# **P802.3dj Physical layer jitter (Clause 176/179) proposal to advance/close current comments against present JRMS and J4u03 methodologies Presented to IEEE P802.3dj Electrical Task Force January 2025. Version 1.1: January 20, 2025**

**Abstract: Comments recorded against P802.3dj D1.3 (306, 219, 220, 221) are calling out for improved handling of jitter. Based on the straw-polling of gines\_3dj\_optx\_01a\_250109.pdf conducted on 01/09/2025 this contribution drives to addressing these comments**

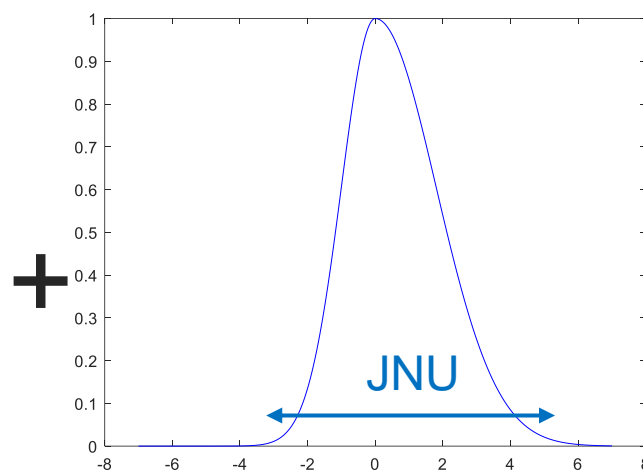
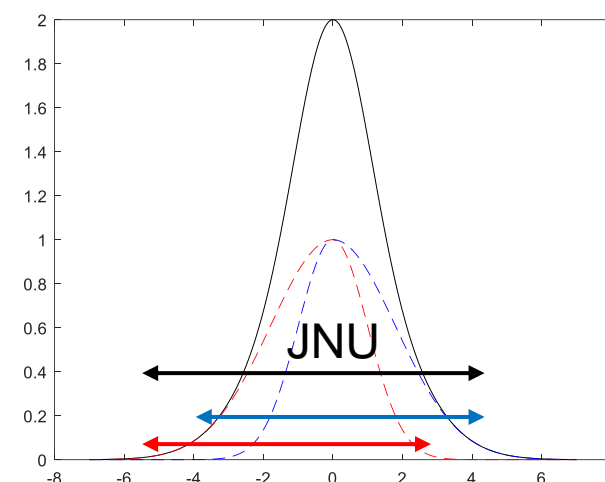
Jitter measurements refer to 120D.3.1.8.1 for the probability distribution calculation method... The method of combining the distributions should be improved to mitigate additive noise and slope dependence.

The composite histogram can have a higher JNU value than the sum of individual JNU values when histograms are not symmetric. This example shows a long tail to the left for rising, and a long tail to the right for falling edges. An additional influence on the symmetry of these distributions is biased by the pre-transition and post-transition run-length.

### 120D.3.1.8.1 J4u and J<sub>RMS</sub> jitter

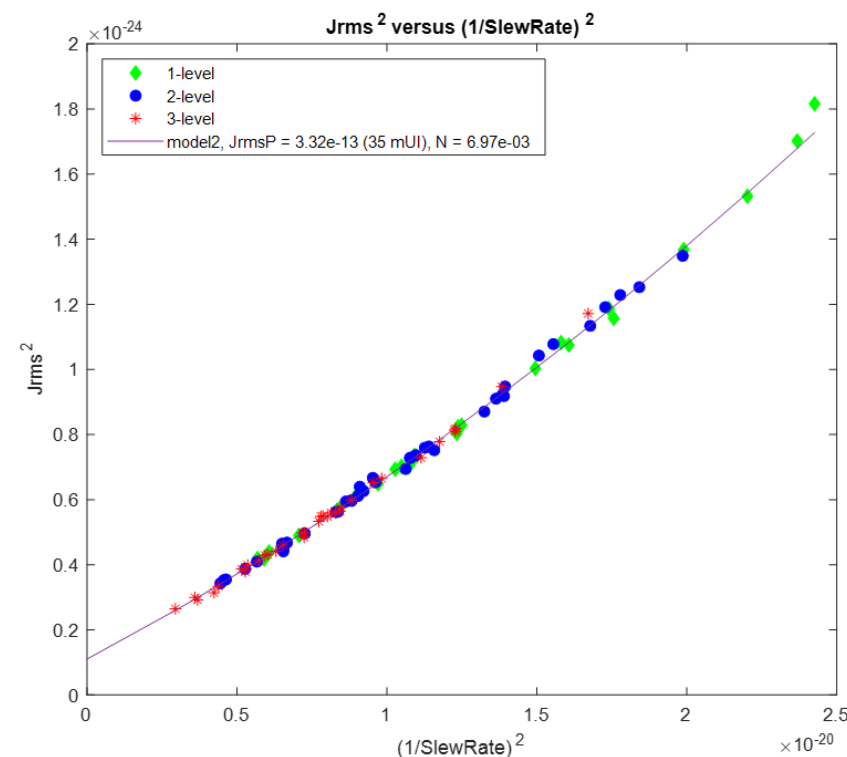
Jitter measurements refer to 120D.3.1.8.1 for the probability distribution calculation method... The method of combining the distributions should be improved to mitigate additive noise and slope dependence.

- As illustrated in [calvin\\_3dj\\_01b\\_2407](#) Pg 7, the process of “combining the sets” results a composite result that is substantially greater than the sum of its parts.
- Rising edge Jnu histograms have a “left” bias, and corresponding falling edge histograms have a “right” bias. “Combining” or adding these two histograms into a composite value has always been problematic.
- It is recommended that within a given transition level class (e.g. 3 level transitions) that the composite value be associated with the **RMS (root mean squared)** of the individual distributions, not their sum.

## Q-Scale and Jitter components (Rj only)

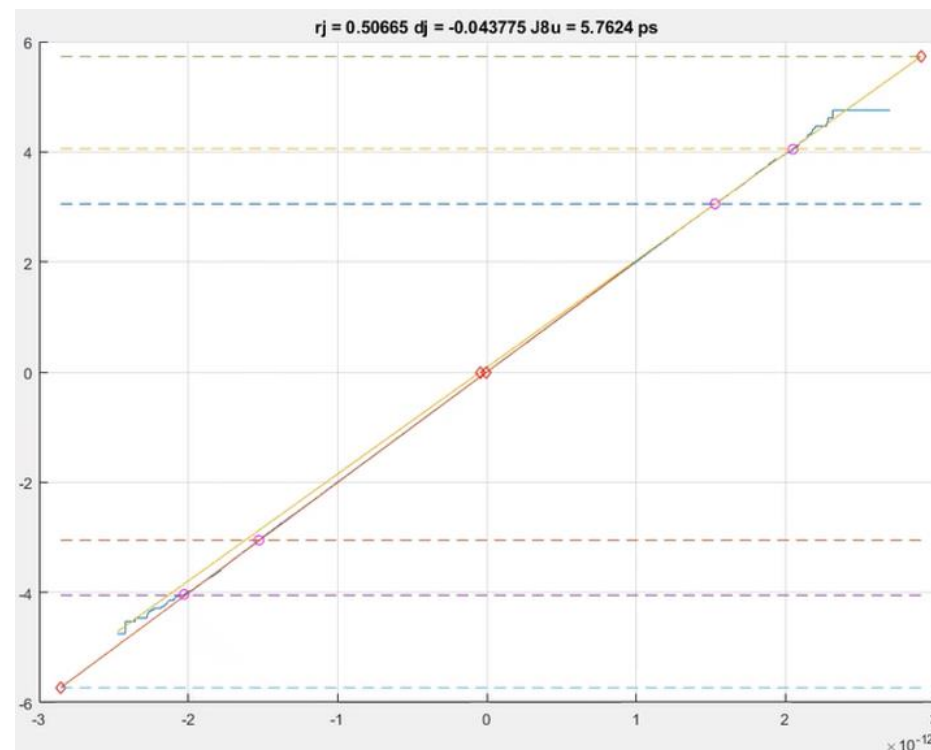
- The Q-Scale transform offers a method of transforming a probability distribution into Q-Space
- It's an effective means to both determine how Gaussian a distribution is, and to predict lower probability behavior.

## Q-Scale and Jitter components (Rj + DJ)

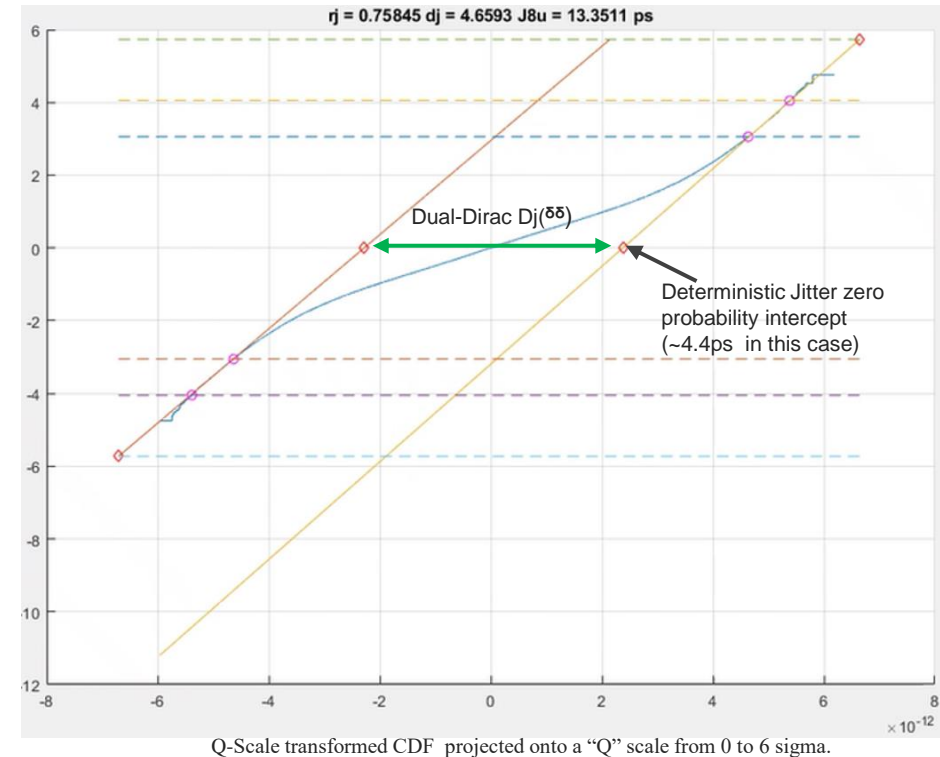
- The JHRMS relies on a "y-intercept" method of determining the random jitter.
- This DJHdd similarly operates on a "x-intercept" of the Q-Scale transformed edge distributions.

# RJ Compensation 12-edge Synthetic 5mv RN,40mUI DJ, 31dB Channel 0RJ

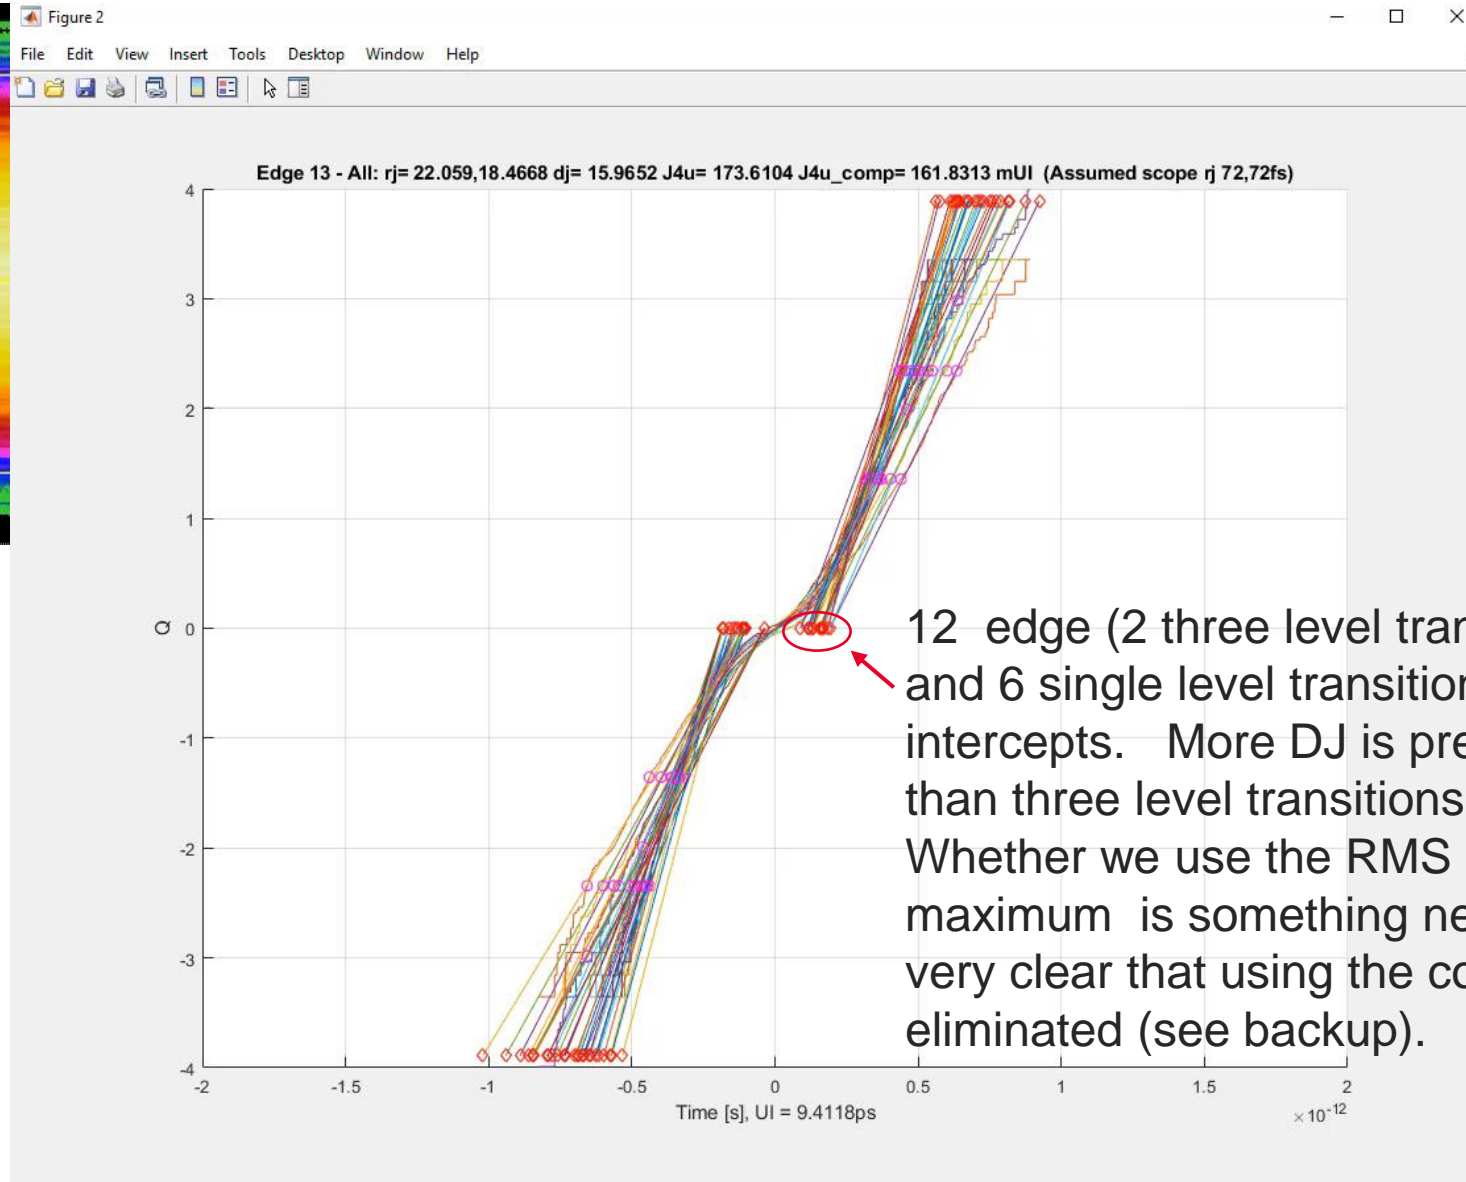
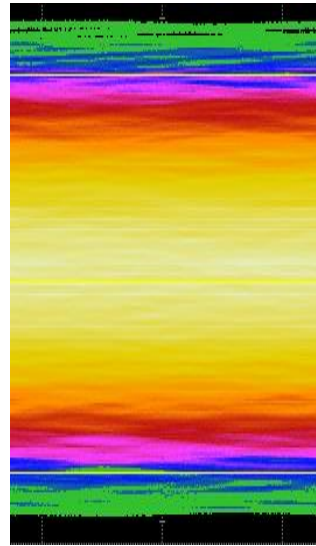
12 edge (2 three level transitions, 4 two level transitions and 6 single level transitions) provide a distribution of x-intercepts. More DJ is present in single level transitions than three level transitions.

Whether we use the RMS of these DJ intercepts, or maximum is something needing research. One thing is very clear that using the composite edge needs to be eliminated (see backup).

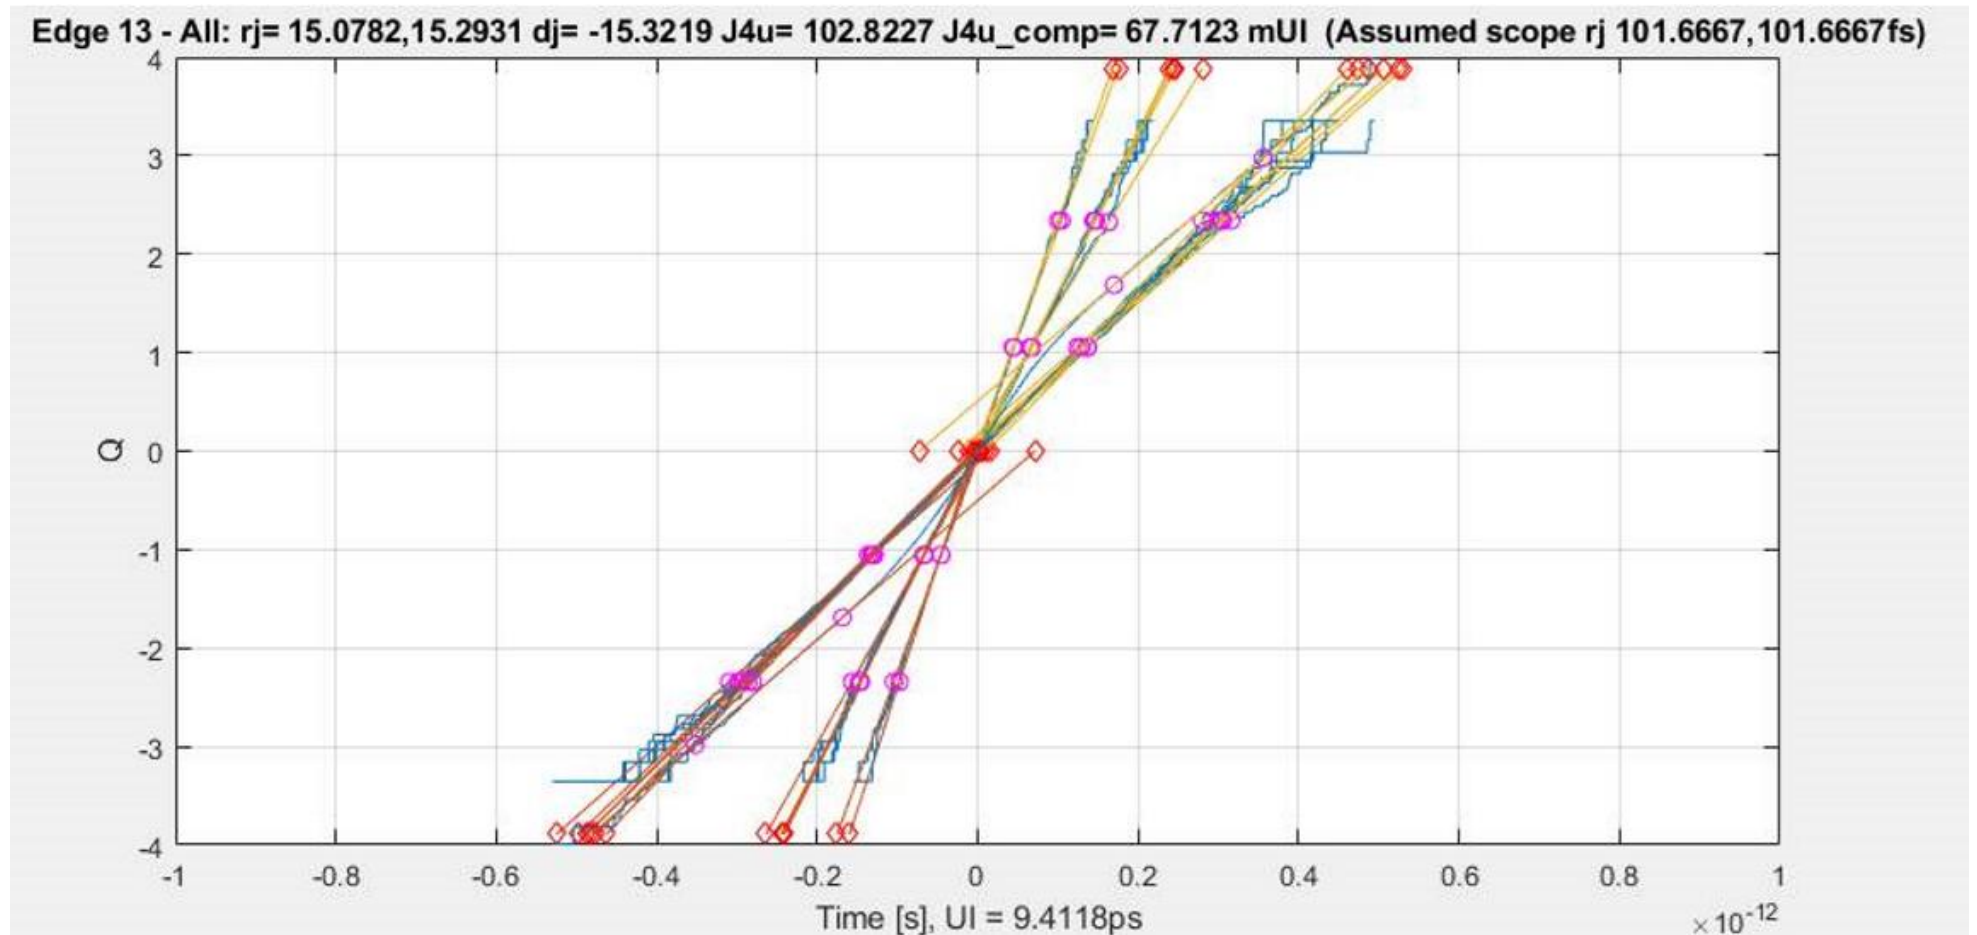
EOJ<sub>03</sub> is calculated using the measurement method specified in 162.9.4.7 for even-odd jitter, except that  
only the transitions R03 and F30 are used.

[calvin 3dj 01b 2407.pdf](#) (Pg 7) Suggested that the reported EOJ03 should be the RMS (root mean squared) of the two (0->3, 3->0) three level EOJ values.

- EOJ03 is sound from a methodology standpoint, however the composite aspect should be eliminated and the RMS (root mean squared) of the rising EOJ03 or the falling EOJ03 should be reported.
